COMPREHENSIVE MONITORING PROGRAM

FINAL TECHNICAL PLAN

Version 3.2

GROUND WATER

FIGURE 1.1-2

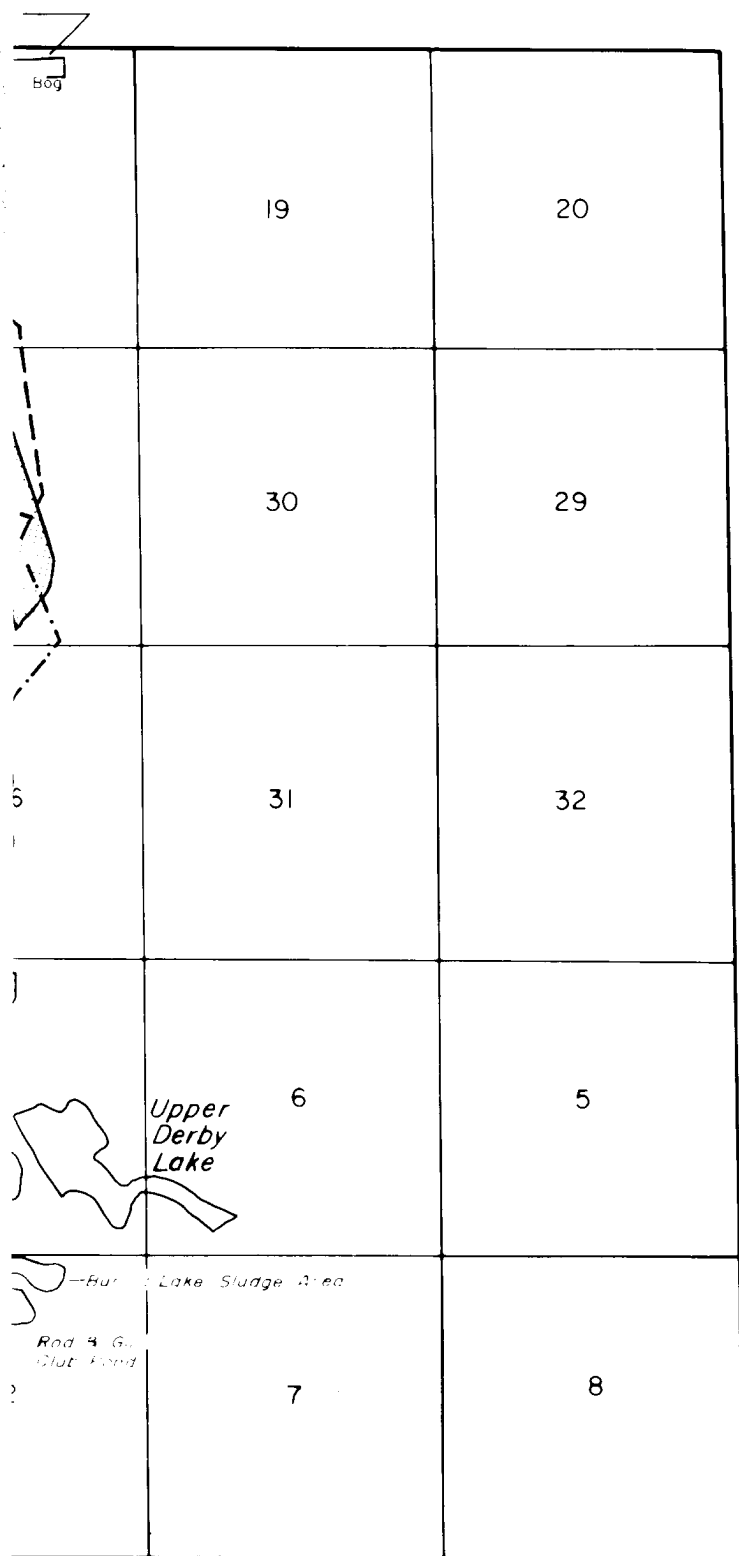
For consistency with the second full paragraph on page 3, solid waste disposal areas and the chemical sewer system should be shown in Figure 1.1-2.

Response: Figure 1.1-2 will be revised accordingly.

FIGURE 1.3-4

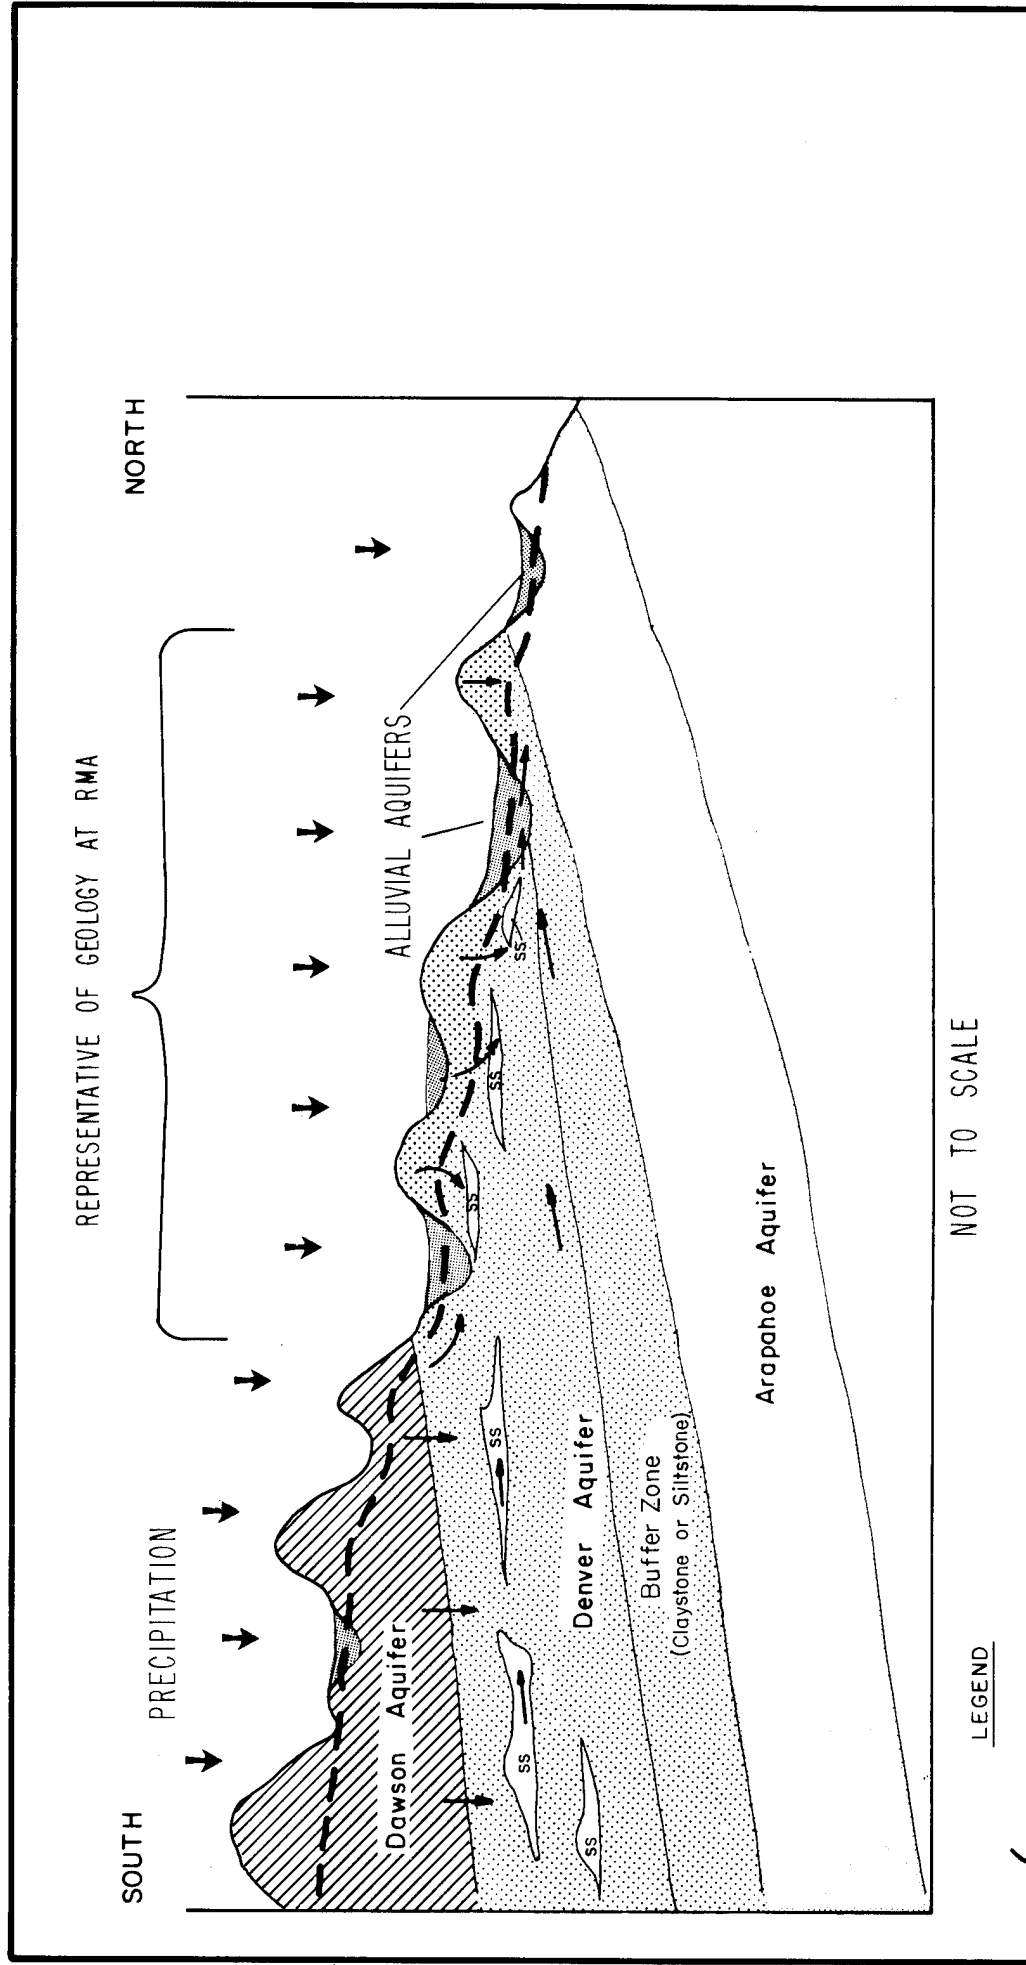
Comment 5: Figure 1.3-4, put in parenthesis by Buffer Zone claystone or siltstone. This will clarify what comprises the buffer zone.

Response: Figure 1.3-4 will be revised to indicate that the Buffer Zone is claystone or siltstone.

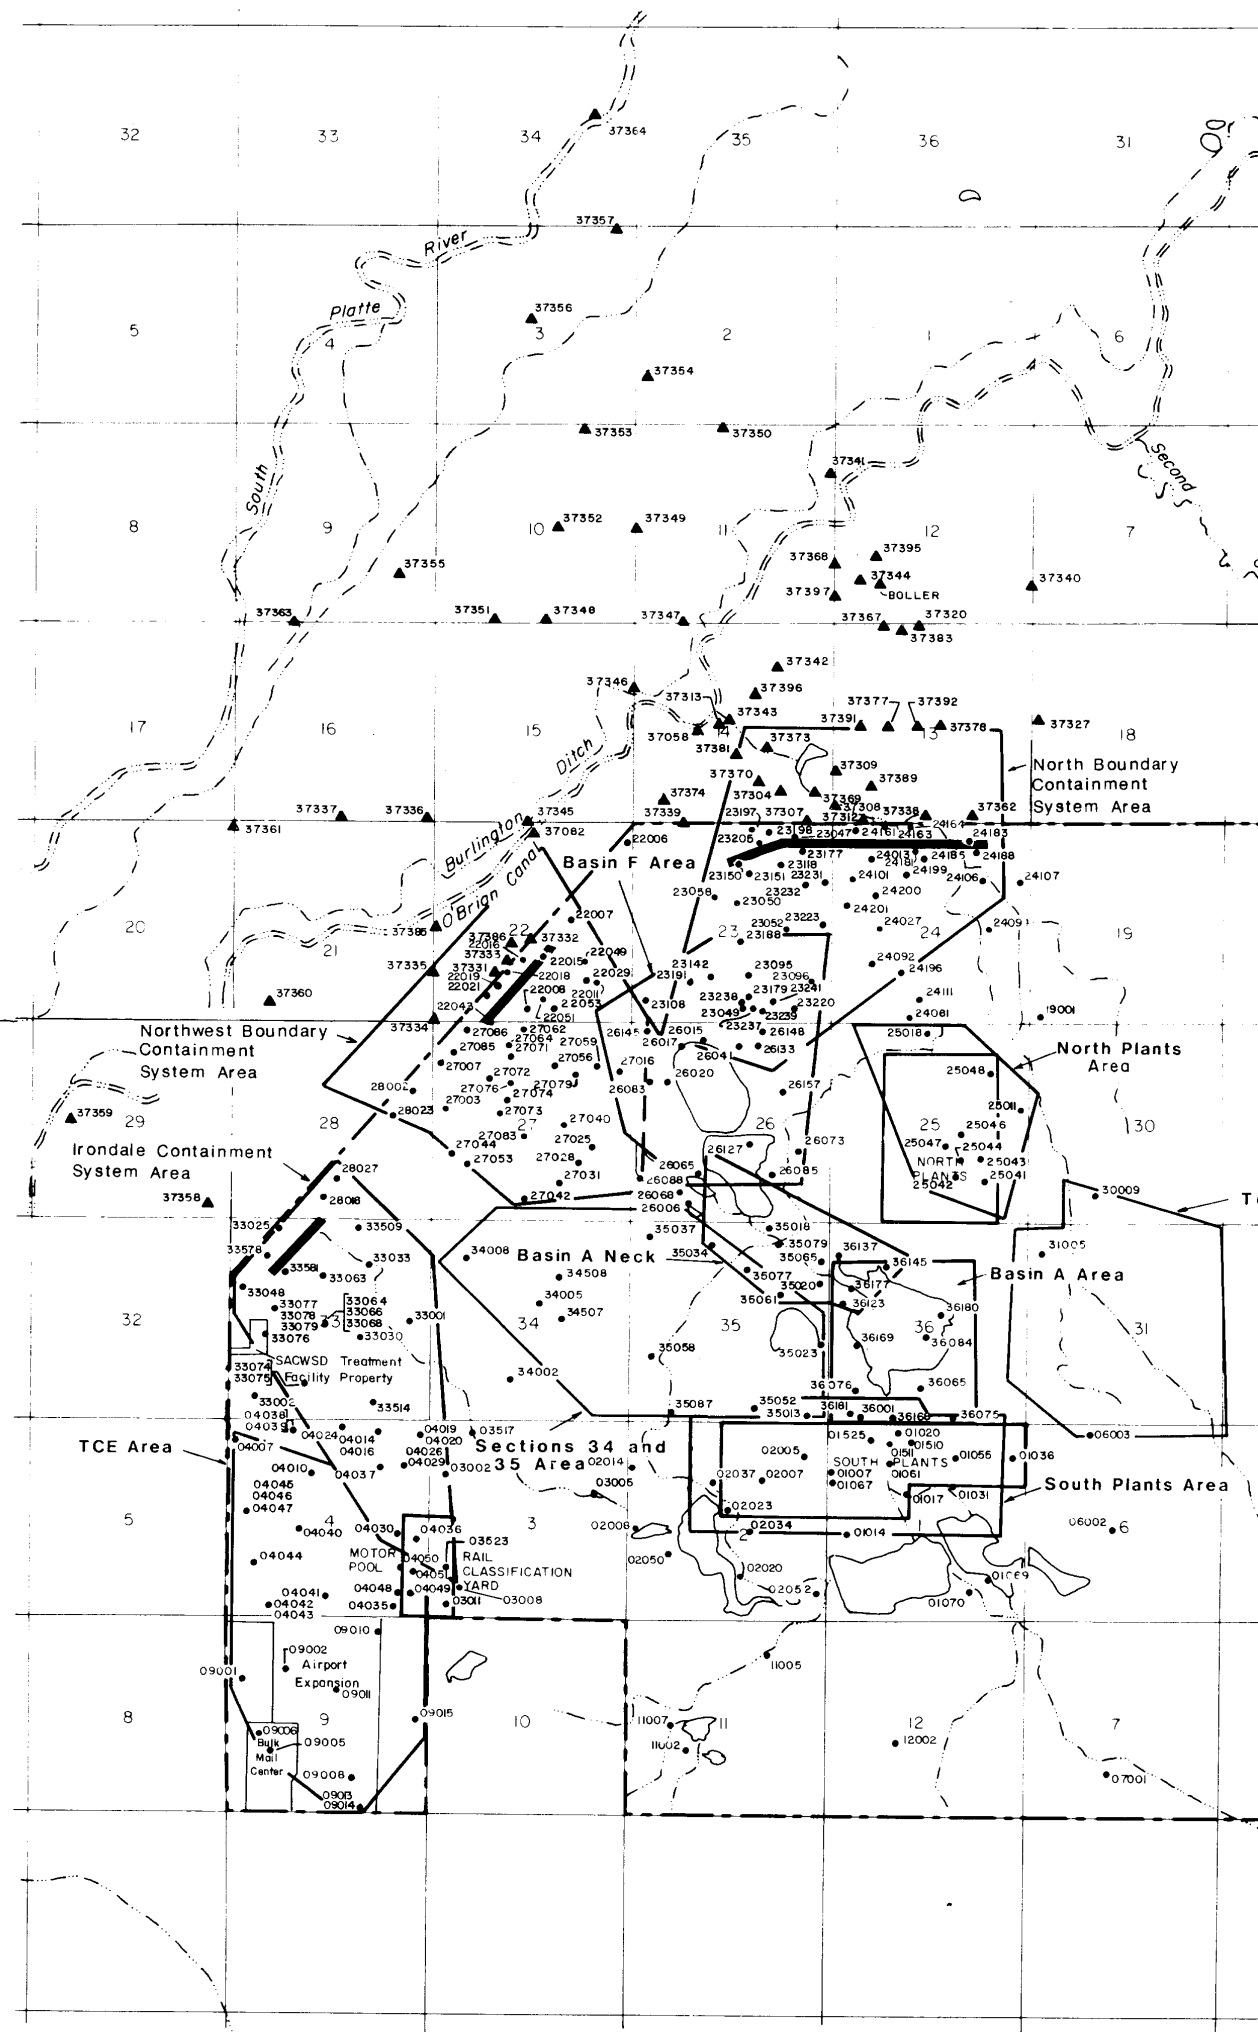
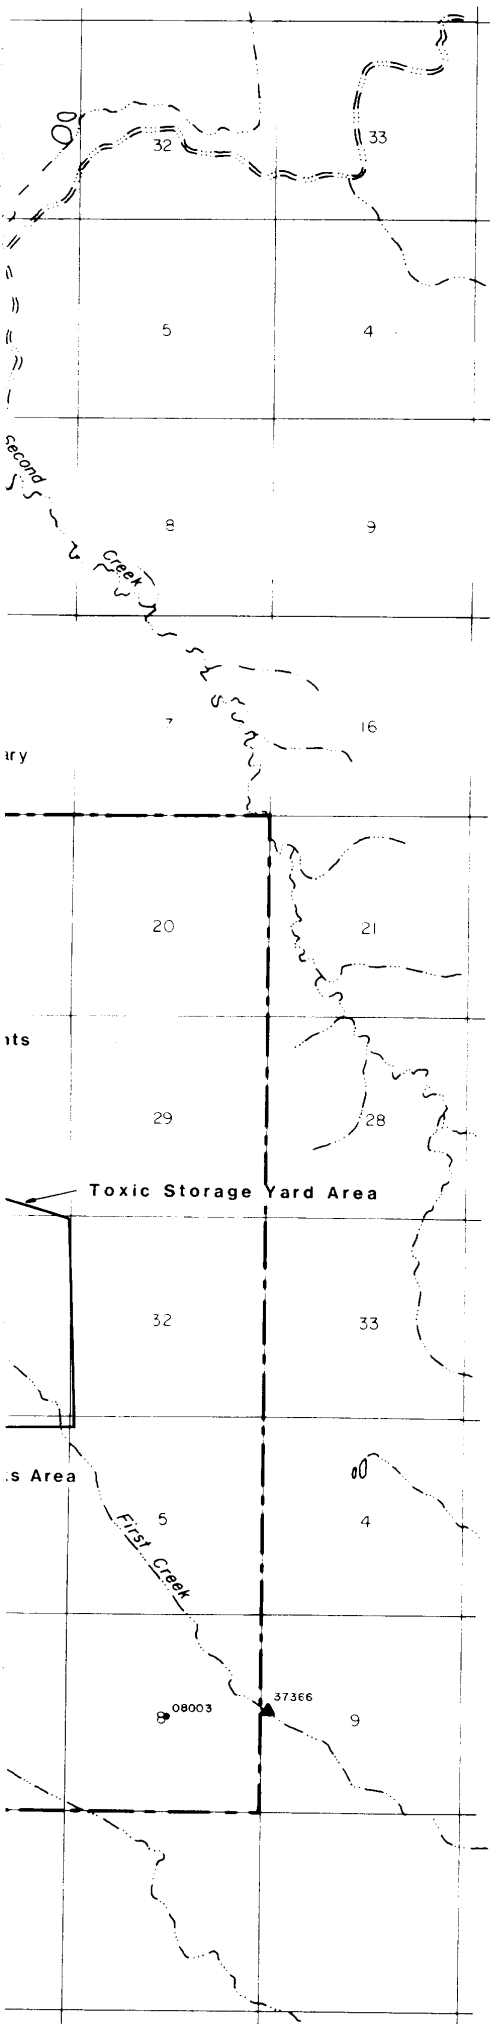
Comment 13. **Pgs. 46-51 and Plates 2.3-1 and 2.3-2** - All additional wells to be included in the program should be added to the appropriate lists and Plates. Well 24136 is missing from Plate 2.3-2. Well 26061 is included on Plate 2.3-2 but not on one of the lists.

Comment 8: Not all Denver formation wells listed in Table 2.3-4, show up on Plate 2.3-2. Well 37390 is not shown.

Response: The Draft Final CMP Technical Plan, Plates 2.3-1 and 2.3-2 present wells that comprise the annual monitoring-well network. The wells mentioned in the Plates for the semi-annual or quarterly monitoring-well networks were not included in this plan. Modifications to any of the monitoring networks will be reflected in revised lists and Plates. The errors identified have been noted.

Response: The wells presented on Plates 2.3-1 and 2.3-2 correspond to the wells listed in Table 2.4-1. These wells comprise the CMP annual sampling event. Wells sampled semi-annually and quarterly are included within the annual well network.
